Sherwood

Sherwood GV Industrial Valve Safety Notice
3 / 4"-16 UNF Straight Thread Only w/ CGA 540, 580, 326 and BS 3 Outlets

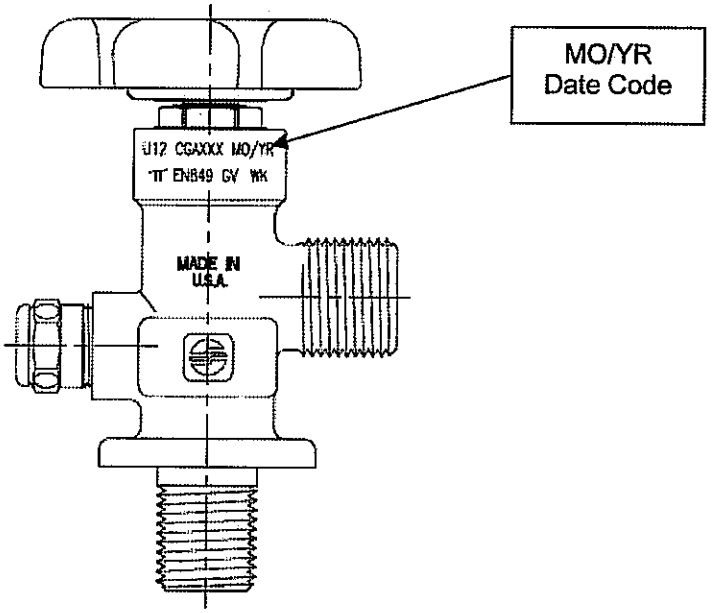
In 2006, a design modification was made to the inlet connection on the 3 / 4"-16 UNF Straight Thread valves with CGA 540, 580, 326, and BS 3 outlet connections. Recently we have been informed certain torques applied during installation may cause a fracture at the ¾"-16 UNF valve inlet thread.

Strictly as a precautionary measure, Sherwood recommends that valves with the part numbers below marked with date codes of 05/06 (May 2006) through 06/07 (June 2007) be safely removed from service and returned for replacement.

Only these part numbers and date codes are to be returned for replacement. Request for returns must be submitted within 90 days of this notice.
